Access Compliance Report Public Rights-of-Way (Curb Ramps)

Main Street: WINDMILL_AVE		Cross Street: N/A		Location:	N
---------------------------	--	-------------------	--	-----------	---

ADA ID: RPRK211110113451	Ramp Type: Type 4 - Parallel	Initial Pass/Fail: Fail	Overall Compliance: No	Severity Score:	15
--------------------------	------------------------------	-------------------------	------------------------	-----------------	----

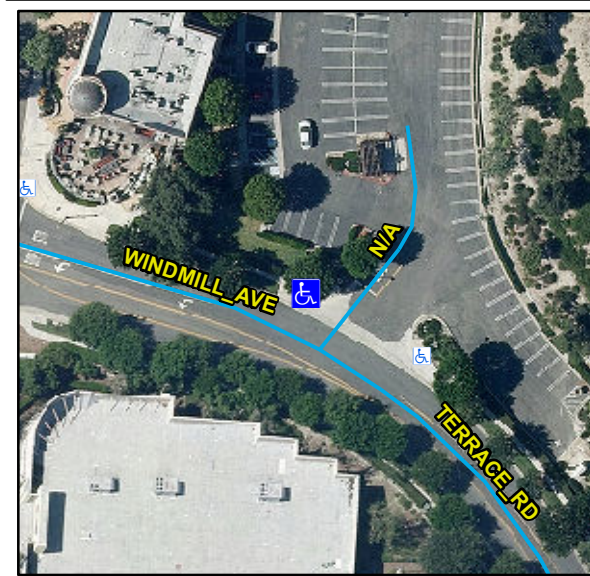
Compliance	Description	Data	Compliance	Description	Data
N/A	Ramp Length LT (in)	138	N/A	Ramp Length RT (in)	140
Yes	Ramp Width LT (in)	89	Yes	Ramp Width RT (in)	89
Yes	Ramp Run Slope LT (%)	2.4	Yes	Ramp Run Slope RT (%)	8.1
No	Ramp Cross Slope LT (%)	3	No	Ramp Cross Slope RT (%)	5.6
N/A	Landing Present	N/A	N/A	DWS Provided	N/A
N/A	Landing Length (in)	N/A	N/A	DWS Contrast	N/A
N/A	Landing Width (in)	N/A	N/A	DWS Length (in)	N/A
N/A	Landing Run Slope (%)	N/A	N/A	DWS Full Width	N/A
N/A	Landing Cross Slope (%)	N/A		DWS Offset Type	N/A
N/A	Landing Movement Obstructed?	N/A	N/A	DWS Offset Left (in)	N/A
	Landing Movement Type	N/A	N/A	DWS Offset Right (in)	N/A
N/A	Landing Shared	N/A			
N/A	Clear Space	Yes			
N/A	Clear Space To Crosswalk (in)	N/A			
N/A	Marked Crosswalk 1	No	N/A	Marked Crosswalk 2	No
	Crossing 1 Direction	SW		Crossing 2 Direction	SE
	Marked Crosswalk 1 Width (in)	N/A		Marked Crosswalk 2 Width (in)	N/A

Remove & Replace Curb Ramp With Two New Directional Ramps or Equivalent.

R204.3, R304.5.3, STD 1115
